UNITED STATES PATENT AND TRADEMARK OFFICE

Interview Summary

Application No.
09/629,277

RE: Interview for U.S. Patent Application No.
09/629,277

FIG. 1

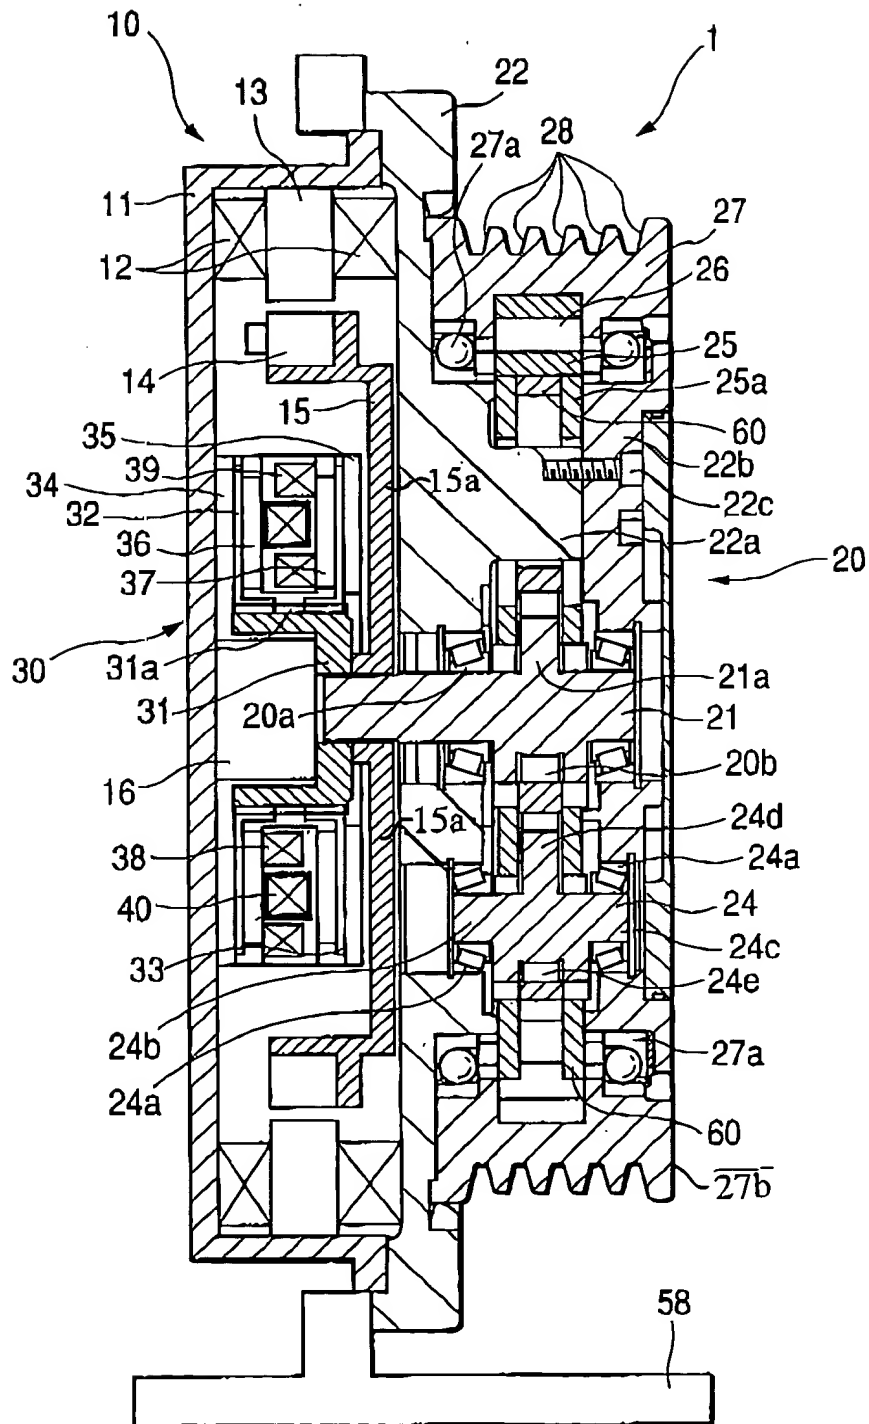
As shown in Fig. 1, the speed-reducer 20 includes the input shaft 21 which is rotatably supported by ~~means of~~ a bearing 20a at a center part of the support member 22 (a rotation center of the speed-reducer). Aa sheave 27 is attached to the speed-reducer 20 as an output rotary wheel which is rotatably supported by ~~means of~~ a pair of bearings 27a at an outer circumference of the support member 22. The sheave 27 is provided with grooves 28 on an outer periphery thereof to be wound by a rope 29 (Fig. 2), and is provided with a predetermined number of internal teeth at an inner periphery thereof, ~~a~~ A plurality of external teathed gears 60 ~~which are engaged at their inner circumferences with a crank portion 21a of the input shaft 21 by means of bearings 20b, and each of which has a predetermined number of teeth on its outer circumference, and a~~ A plurality of support shafts 24 ~~which are supported by the support member 22 at their opposite ends 24b, 24c by means of bearings 24a, and support a plurality of the external teathed gears 60 by means of bearings 24e at their crank portions 24d.~~
